Access Compliance Report

Public Rights-of-Way

(Curb Ramps)

Intersection ID: 47468	Main Street: MILLSTREAM RIDGE DR	Cross Street: ELENLIL LN	Location: SE
ADA ID: A4704883B106	Ramp Type: Perp	Initial Pass/Fail: Fail	Overall Compliance: No
Severity Score: 60			
Codes/Mitigation Info/Possible Solution		Field Measurements/Component Compliance

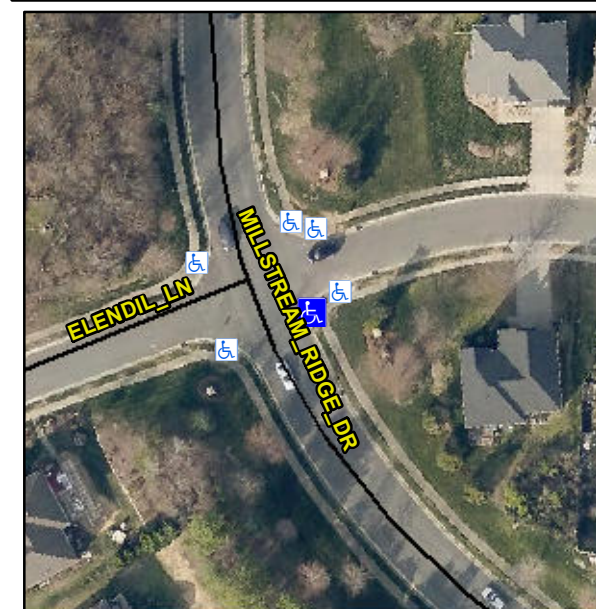
Remove & Replace Entire Ramp.

R304.5.1, R304.2.2, R304.5.3

Compliance	Description	Data	Compliance	Description	Data
N/A	Ramp Length (in)	55.0	No	Ramp Slope (%)	8.7
No	Ramp Width (in)	26.0	No	Ramp XSlope (%)	6.9
N/A	Flare Type LT	N/A	N/A	Flare Type RT	N/A
N/A	Flare Slope LT (%)	N/A	N/A	Flare Slope RT (%)	N/A
N/A	Flare Traversable LT?	N/A	N/A	Flare Traversable RT?	N/A
N/A	Landing Length (in)	N/A	N/A	DWS Provided?	N/A
N/A	Landing Width (in)	N/A	N/A	DWS Contrast?	N/A
N/A	Landing Slope (%)	N/A	N/A	DWS Length (in)	N/A
N/A	Landing X Slope (%)	N/A	N/A	DWS Full Width?	N/A
N/A	Landing Curb? (Y/N)	N/A	N/A	DWS Offset (in)	N/A
N/A	Shared Landing?	N/A			
N/A	Gutter Ponding?	N/A	N/A	Gutter Slope (%)	N/A
N/A	Gutter Lip Ht (in)	N/A	N/A	Gutter X Slope (%)	N/A
N/A	Painted X Walk1?	No	N/A	Painted X Walk2?	N/A
	X Walk 1 Direction	To W		X Walk 2 Direction	N/A
N/A	X Walk 1 Width (in)	N/A	N/A	X Walk 2 Width (in)	N/A
	X Walk 1 Slope (%)	5.1		X Walk 2 Slope (%)	N/A
	X Walk 1 X Slope (%)	8.3		X Walk 2 X Slope (%)	N/A
